Contract #: 04-0120F4Cty: SF/ALA Rte: 80 PM: 13.2/13.9File #: 69.25B**QUALITY ASSURANCE -- NON-CONFORMANCE REPORT****Location:** Changxing Island, Shanghai, P.R. China**Report No:** NCR-000880**Prime Contractor:** American Bridge/Fluor Enterprises, a JV**Date:** 28-Oct-2010**Submitting Contractor:** Zhenhua Port Machinery Company, Ltd (ZPMC), Changxing Island**NCR #:** ZPMC-0842**Type of problem:**

**Reference Description:** QA found a missed UT indication after ZPMC had tested and accepted the weld in OBG Steel Barrier W2-SB9-017

**NON-CONFORMANCE REPORT TRANSMITTAL**

## NCR PROPOSED RESOLUTION

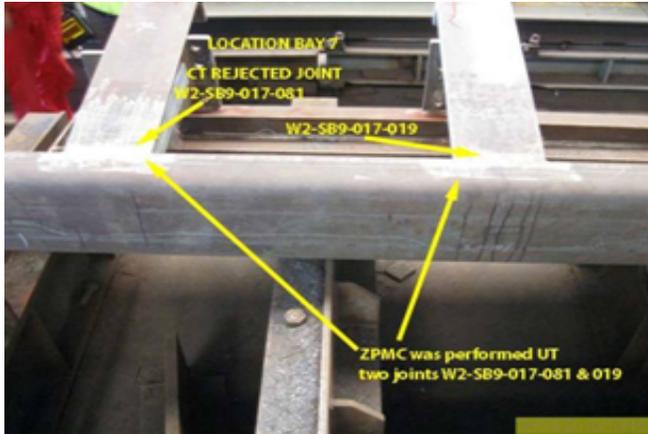
During the Quality Assurance (QA) Ultrasonic Testing (UT) review of weld located on the Steel Barrier (SB), this QA Inspector discovered the following issue:

- One Class "A" rejectable indication measuring approximately 10 mm in length.
- The indication rating is -4dB.
- The depth of the indication was 5-6 mm
- The weld joint is identified as W2-SB9-017-081.
- This weld is a Complete Joint Penetration (CJP) splice joint, joining SB Skin plate to the Diaphragm Flange plate.
- The thickness of the steel material is 12 mm.
- The "Y" location is approximately 35 mm from the nearest end of the weld.
- The indication is clearly marked on or near the weld.
- This SB is located in sub assembly Bay # 7.

The Notice of Witness Inspection Number (NWIT) is 07136. The indication is located within the area that has been previously tested and accepted by ZPMC Quality Control (QC) personnel. As per the contract documents, ZPMC's QC personnel are required to perform 10% UT inspection of this weld.

**Reference Resolution:** ZPMC has repaired the indication noted in the NCR and is providing NDT documentation after the repair to show the indication has been removed.

ZPMC has repaired the indication noted in the NCR and is providing NDT documentation after the repair to show the indication has been removed. ABFJV has noted which inspector was responsible for this missed indications and is monitoring his performance as well as all inspector performance, if he continues to miss indications disciplinary action will be undertaken. Based on these actions, ZPMC requests closure of this NCR.

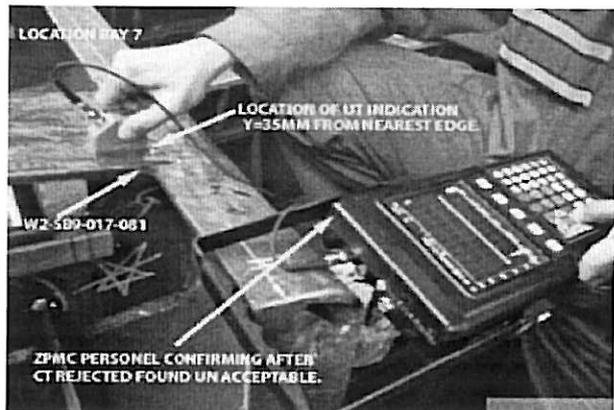
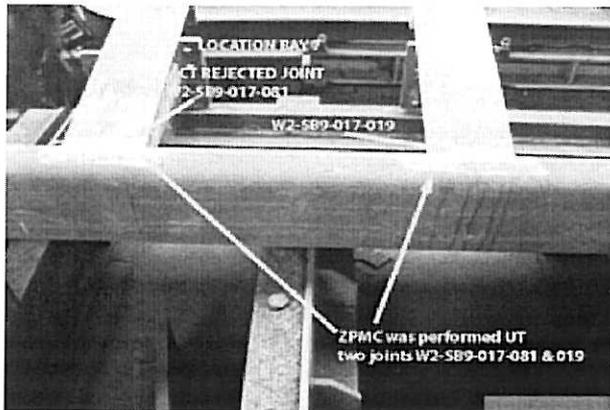
During the Quality Assurance (QA) Ultrasonic Testing (UT) review of weld located on the Steel Barrier (SB), this QA Inspector discovered the following issue:

- One Class "A" rejectable indication measuring approximately 10 mm in length.
- The indication rating is -4dB.
- The depth of the indication was 5-6 mm
- The weld joint is identified as W2-SB9-017-081.
- This weld is a Complete Joint Penetration (CJP) splice joint, joining SB Skin plate to the Diaphragm Flange plate.
- The thickness of the steel material is 12 mm.
- The "Y" location is approximately 35 mm from the nearest end of the weld.
- The indication is clearly marked on or near the weld.
- This SB is located in sub assembly Bay # 7.

The Notice of Witness Inspection Number (NWIT) is 07136. The indication is located within the area that has been previously tested and accepted by ZPMC Quality Control (QC) personnel. As per the contract documents, ZPMC's QC personnel are required to perform 10% UT inspection of this weld.

ZPMC to repair the indications noted in the NCR and provide NDT documentation to confirm the indications removed and repaired. The inspector involved has been identified and his performance will be closely monitored. Appropriate disciplinary action will be taken should his performance is not improved in future.

The missed indications have been removed and NDT report has been submitted to verify the repair has been completed satisfactorily. The inspector involved was disciplined and his performance is being monitored.

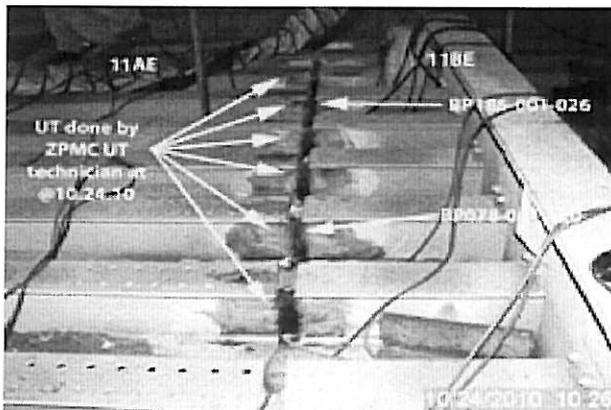
During the Quality Assurance (QA) Ultrasonic Testing (UT) review of welds located on Orthotropic Box Girder (OBG) Segment 11AE to 11BE splice joint, this QA Inspector discovered the following issues:

- Two (2) longitudinal linear Class "A" rejectable indications measuring approximately 20 and 25mm in length.
- The welds are identified as BP186-001-026 and BP078-001-020 respectively.
- Material thickness is 10mm.
- The depth of the indications: approximately 6 and 8mm respectively.
- The indication dBs ratings are +7 and +9 respectively.
- The welds are Complete Joint Penetration (CJP) butt joints, joining bottom plate T-ribs on 11AE to bottom plate T-ribs on 11BE.
- The welds are designated as non Seismic Performance Critical Material (Non SPCM).
- The indications are clearly marked near the welds.
- The Y distance for weld joint BP186-001-026 is 35 mm from bottom cope hole.
- The Y distance for weld joint BP078-001-020 is 45 mm from bottom cope hole.
- The segments are located in the OBG Trial Assembly area.

The Notice of Witness Inspection (NWIT) No. is 007134. The indications are located within an area previously tested and accepted by ZPMC Quality Control (QC) personnel. Per the contract documents, ZPMC's QC personnel are required to perform 25% UT inspection of these welds.

For indication location details, see the attached Photos (The first photo, dated 10/24/10, is included in this incident report for the purpose of confirming that ZPMC QC was previously observed by this QA, performing Ultrasonic Testing (UT) on the welds addressed in this report)

ZPMC acknowledged the indications were missed and has issued an internal NCR to address this problem. ZPMC has repaired the indications and is providing the NDT records to show the acceptance of this weld. Based on this, ZPMC is requesting closure of this NCR.
